**Agenda Item:** 7  
**Source:** Siemens AG  
**Title:** RRC Connection Establishment and Release for TDD  
**Document for:** Decision

## 2 RRC Connection Establishment for TDD mode

### 3 RRC Connection Release for TDD mode

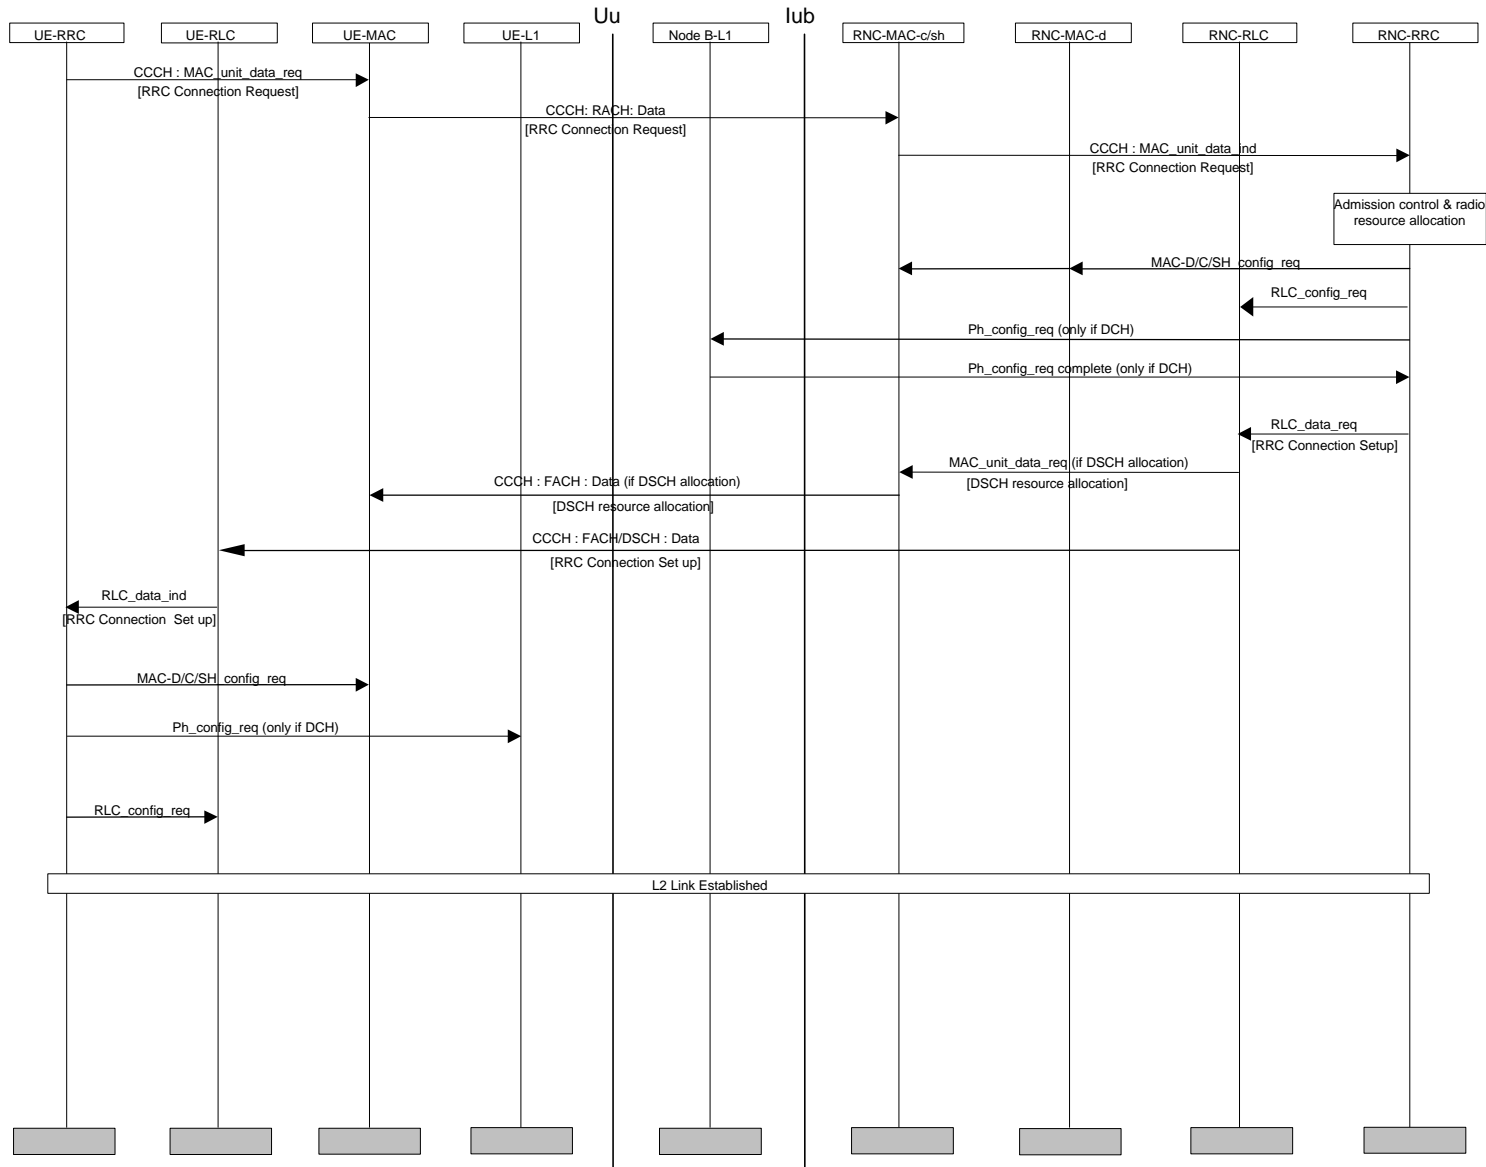
In the following, only the differences to FDD are described.

At the RNC side, the configuration of RNC-MAC-d and RNC-MAC-c/sh is done with *one message* MAC-D/C/SH\_config\_req because these MAC entities are assumed to be in the same RNC and one message is therefore sufficient.

The configuration of NodeB-L1 in case of DCH is done by RNC-RRC using the message "Ph\_config\_req".

For transmission of the "RRC Connection Set Up" message, either the FACH or the DSCH can be used. If the DSCH is used, there will be a DSCH resource allocation message in the FACH before.

In the UE, the configuration of UE-L1 in case of DCH is done by the UE-RRC using the message "Ph\_config\_req". Any L1 synch procedure during channel set up is not required in TDD.

- add the figure as well as the text from *chapter 2 of this Tdoc* in a separate chapter titled "RRC connection establishment for TDD mode" into S2.03, and
- add the figure and the text from *chapter 3 of this Tdoc* in a separate chapter titled "RRC connection release for TDD mode" into S2.03.

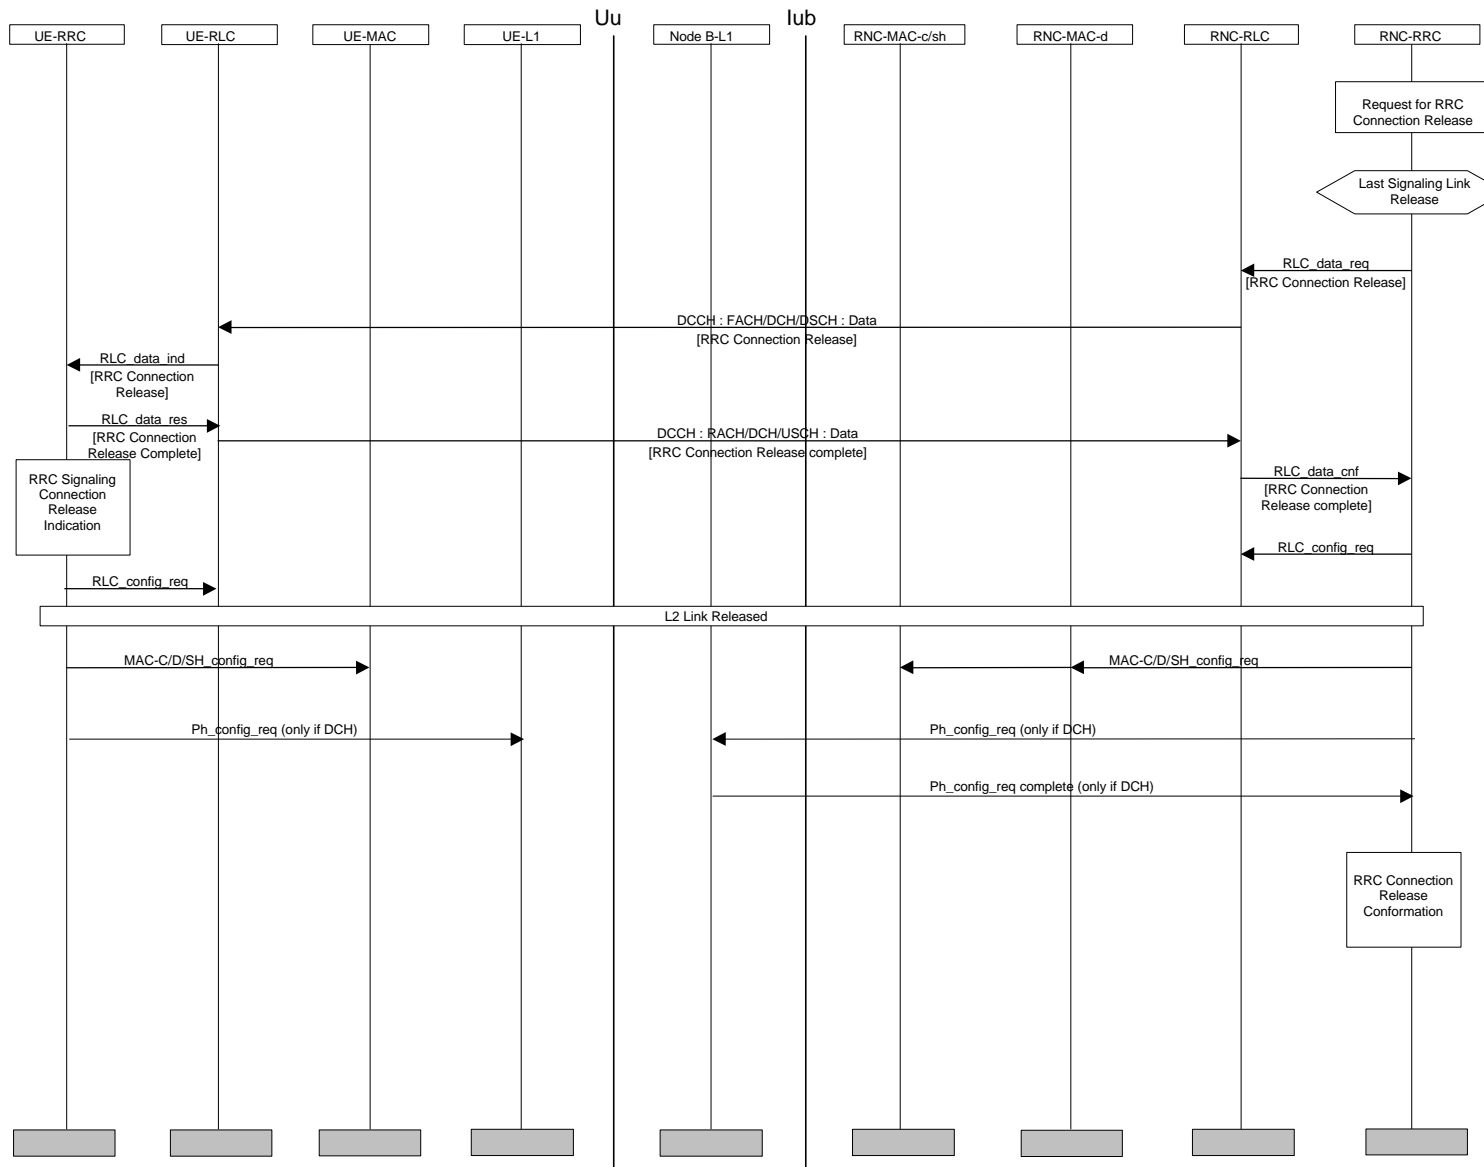
The RRC connection release for TDD is similar to the "RRC connection release without Dedicated Physical Channel" in FDD because in TDD, the RNC-RRC expects the "RRC Connection Release Complete" message from the UE as an acknowledgement and does not rely on the "MPH\_out\_of\_sync\_ind" to see that the DCH has been terminated.

In the following, only the differences of the TDD RRC Connection Release procedure compared to the "RRC connection release without Dedicated Physical Channel" procedure in FDD are described.

The "RRC Connection Release" message from RNC to UE is sent as "Unacknowledged data" because the acknowledgement is expected at RRC level, not at RLC level.

The UE responds by sending the "RRC Connection Release Complete" message as "Unacknowledged data".

At the RNC side, the release of the MAC connection is performed with one primitive "MAC-D/C/SH\_config\_req" from RRC to MAC because the several MAC entities serving the UE are all located in the same RNC.

A potential release of L1 in case of DCH is performed on both sides by RRC using a "Ph\_config\_req" message.
